SERVICE BULLETIN 0807-001
6-29-2012, Revision B

MULTI-GROOVE SUPERCHARGER BELT

Figure 1

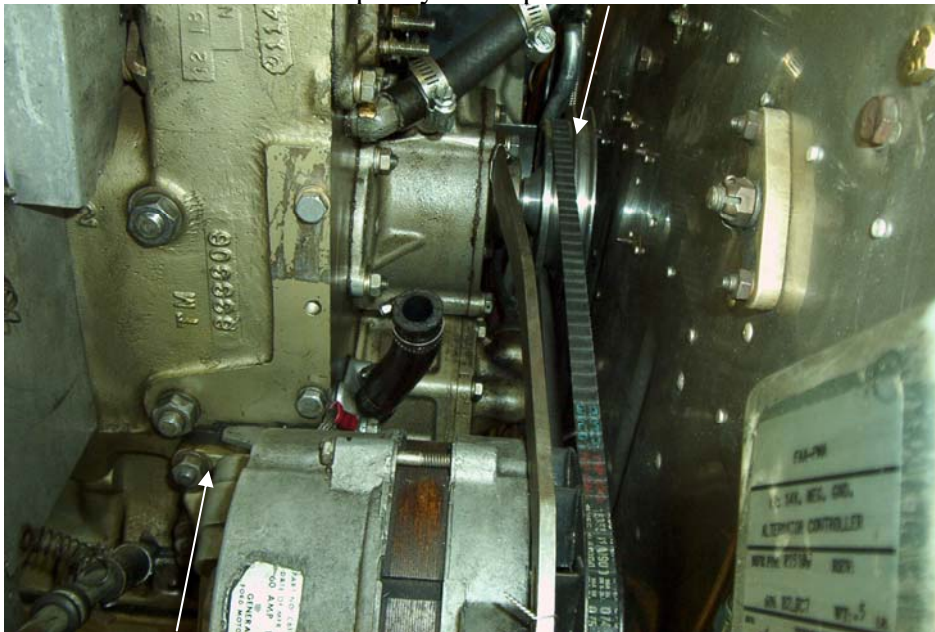
6. Remove the alternator/supercharger drive pulley from the rear of the engine and replace it with the new double pulley, P/N182LR014-2 or 182U014-2, using the existing hardware. Tighten to 37.5 to 41.2 ft. lbs. (Figure 1)

Remove drive pulley and replace with P/N 182LR014-2

Figure 2

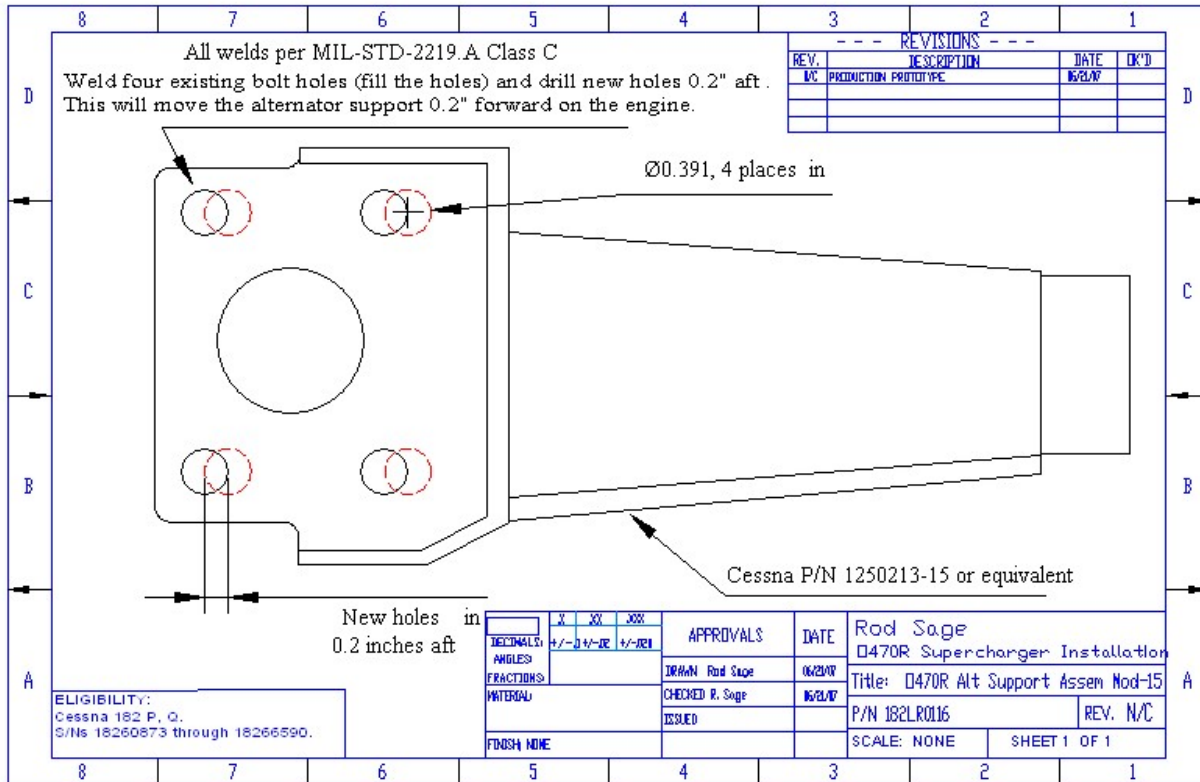
7. Reinstall the alternator belt, FAT P/N 182355, and tighten the belt by rotating the alternator. (Figure 1)
8. Remove the supercharger pulley (figure 2) and replace it with pulley P/N 182LR009-2 using the existing hardware.

Remove supercharger pulley, replace with P/N 182LR009-2
